Docket Item # 2
BAR CASE # 2011-0282

BAR Meeting
January 25, 2012

ISSUE: Request for construction of three multi-family buildings, 27 townhouses, four triplexes and a park in Phase V of the James Bland Redevelopment Project

LOCATION: 1000 First Street and 998 North Alfred Street

Figure 1. 815 1/2 King Street (Old Town Theater/Richmond Theater) as originally constructed with contrasting stone ornament.

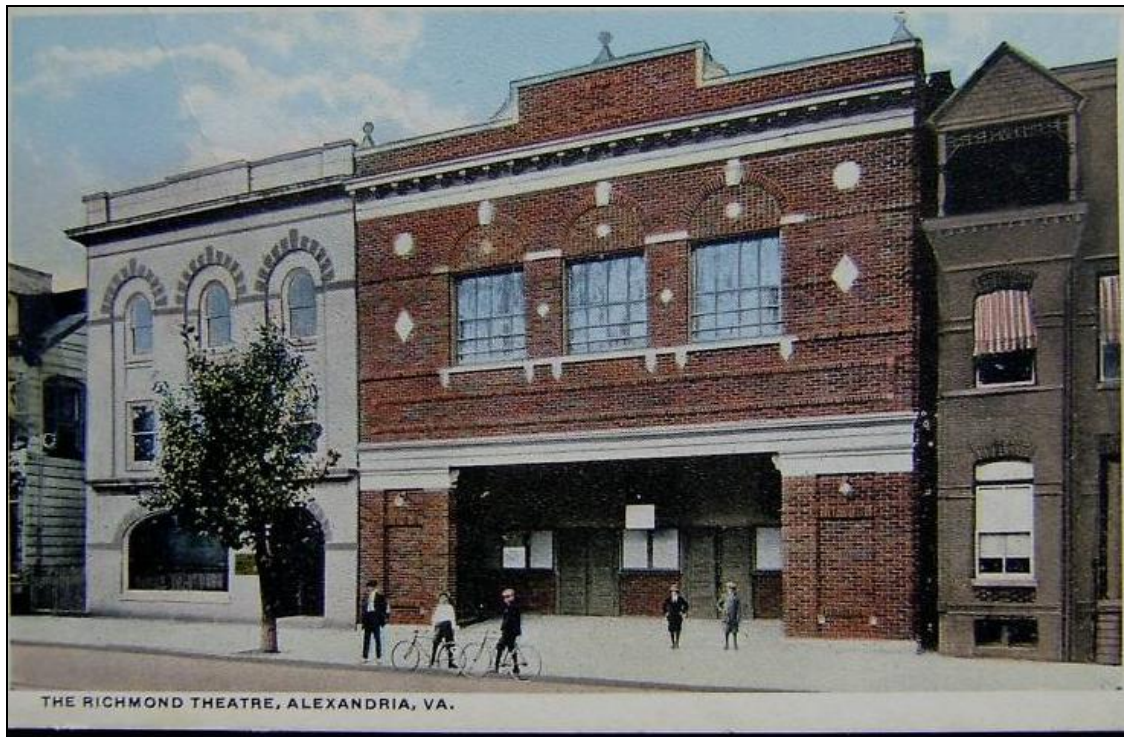
It is useful that the applicant has shown the vents, as the cumulative effect of something seemingly minor can grow to be quite substantial. In this particular case, there are a significant number of vents due to the number units and they are located on all elevations. While the Board's general practice is to condition that vents be painted to match the adjacent wall surface so that they recede, in this case there is an opportunity to turn a utilitarian feature into an inexpensive decorative element. The initial locations of the vents suggest that there could be a way to add small dark tiles/metal plates to the elevations that would serve as a decorative element, as was often done on early 20th century buildings. Matching the vents in size and then thoughtfully considering the vent and tile placement would result in a simple and inexpensive way to add decoration in keeping with the Art Deco spirit that other elements of the building suggest. In order not to overwhelm the project, this element could be added only to the center building as a way to further differentiate the buildings and animate the large expanse of HardiePanel at the top floor.
